IN THE DRAWINGS:

REMARKS

This paper is responsive to a Notice of Non-Compliance mailed April 14, 2005. This response is identical to the paper received at the PTO on April 6, 2005, which was responsive to an Office Action dated March 17, 2004, except that Attachment B has been added. Attachment B includes a corrected copy of Fig. 4 that has been marked "Replacement Sheet". Prior to this response, claims 1-20 were pending. After amending claims 1-20, claims 1-21 remain pending.

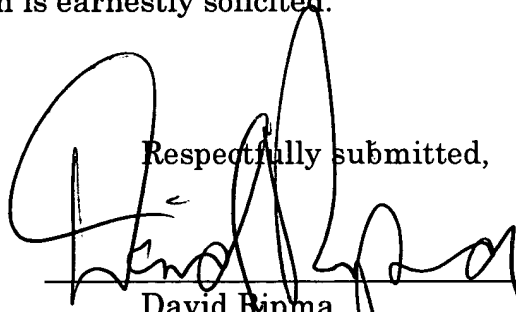
Section 1 of the Office Action objects to the use of reference designator "308" at page 8, line 2, of the specification. Interlevel interconnect "308" is intended to describe a different interconnect than interconnect "306". Therefore, the specification is correct as written. In response to the objection, Fig. 4 has been corrected to show reference designator 308 above top electrode 110.

Section 2 of the Office Action objects to the omission of reference designator 110 in Fig. 4. In response, formal drawings have been prepared to replace the informal drawings. Fig. 4 of the formal drawings shows reference designator 110.

The Examiner has objected to Fig. 4 of the informal drawings, initially submitted with the application. Formal drawings have been prepared and are enclosed as Attachment A. The corrections requested by the Examiner in Fig. 4 have been incorporated into the formal drawings. Attachment B includes a copy of Fig. 4 with corrections, which has been marked "Replacement Sheet".
